BP CHEMICALS, INC.  
MIXED WASTE POND CLOSURE PROJECT

FIELD CHANGE REQUEST FORM

Subject: Anchor Trench Design

Job No: **22007-011-120** ECN No: **BUF-003** Date: **September 25, 1996**

Client BP CHEMICALS Subject REVISED ANCHOR TRENCH DESIGN

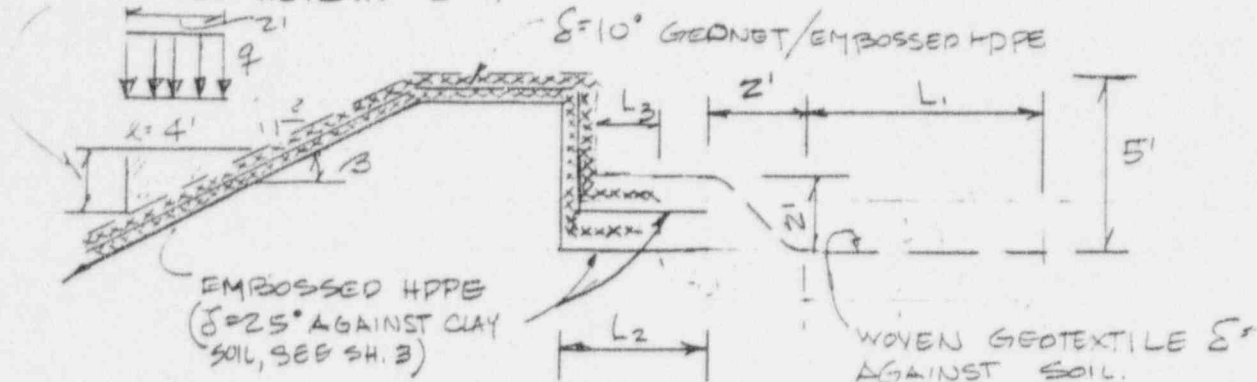
- ASSUME THAT UPPER GEONET AND GEOTEXTILE FUNCTION AS UNIT, BUT THAT LOAD IS CARRIED BY GEOTEXTILE (WOVEN), WHICH HAS HIGHER MODULUS. (ASSUMPTION BASED ON RIDGE FORMATION BY SOIL PRESSING INTO GEONET AND LOCKING ANY SLIPPAGE).
- ASSUME FRICTION OF GEONET TO EMBOSSSED HDPE IS  $\delta = 10^\circ$  (WOVEN SLIT FILM TO HDPE) AND FRICTION OF SAND TO GEOTEXTILE IS  $24^\circ$

$$T = (2480)(\cos 26.6^\circ)(\tan 24^\circ) - (2480)(\cos 26.6^\circ)(\tan 10^\circ) = 600 \text{ LB/FT} \checkmark$$

$$DR = \frac{130}{50} = 2.6 > 2.0 \text{ OK. ; DESIGN ANCHOR FOR FS = 2.0} \checkmark$$

REVISED ANCHOR TRENCH

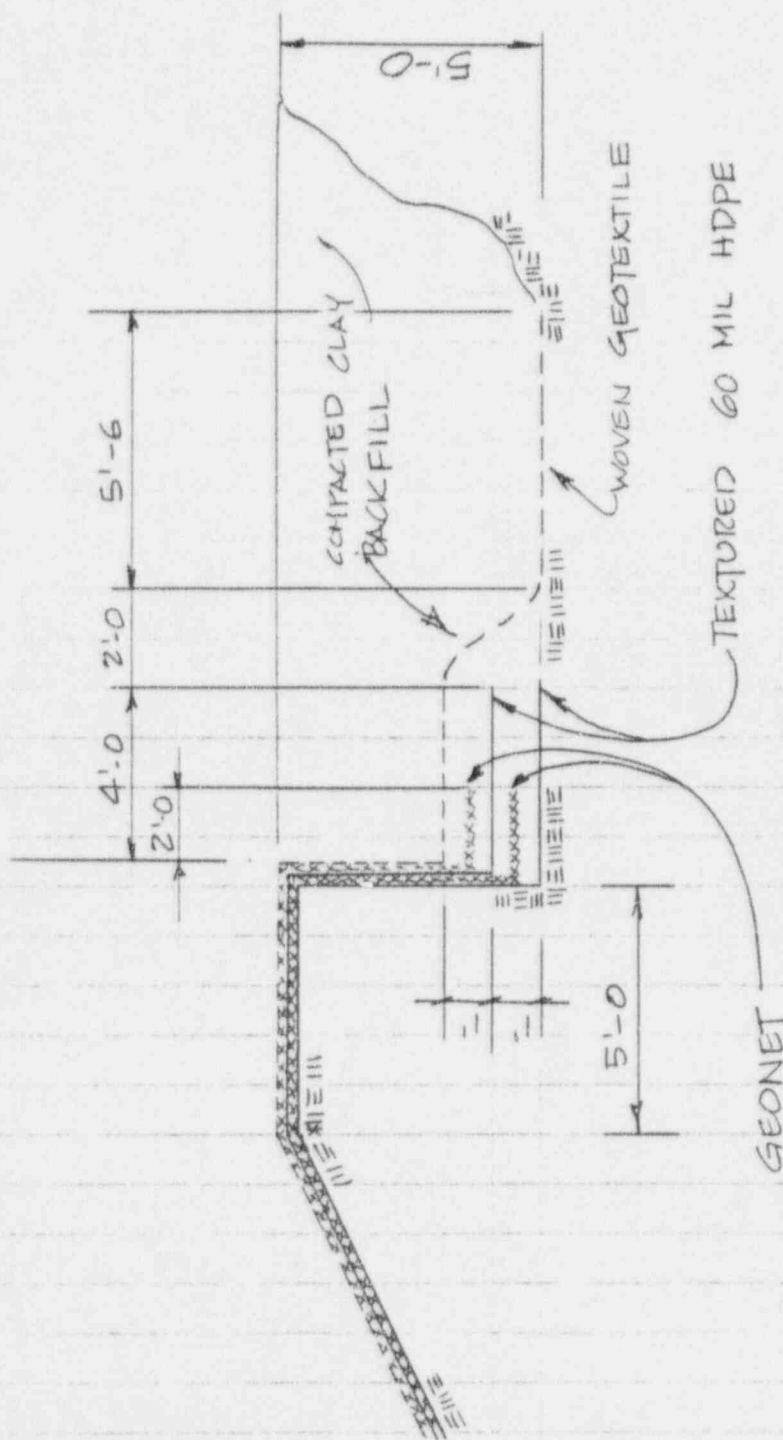
Description: Revise Anchor Trench Design and Backfill Plan

Justification: Constructability problems of original design. Placement and compaction of 1 - foot thick clay layers between synthetic layer on vertical plane of Anchor Trench is not practical.

Change liner material to textured HDPE on slope portion of section. Revise anchor trench per attached sketch.

Textured HDPE selected for all work in consideration of safety. Liner installer proposed alternate anchor trench from the one included in the original design to facilitate construction. As is shown on calculation BUF-96-107 (attached) a revised design can be used in consideration of increased friction coefficient of textured liner material.

$$L = \frac{(600)(2.0) - (3)(120)(4)(\tan 15^\circ)}{(5)(120)(\tan(15))} = 5.1' \quad \underline{\text{SAY } 5'-6} \quad \checkmark$$
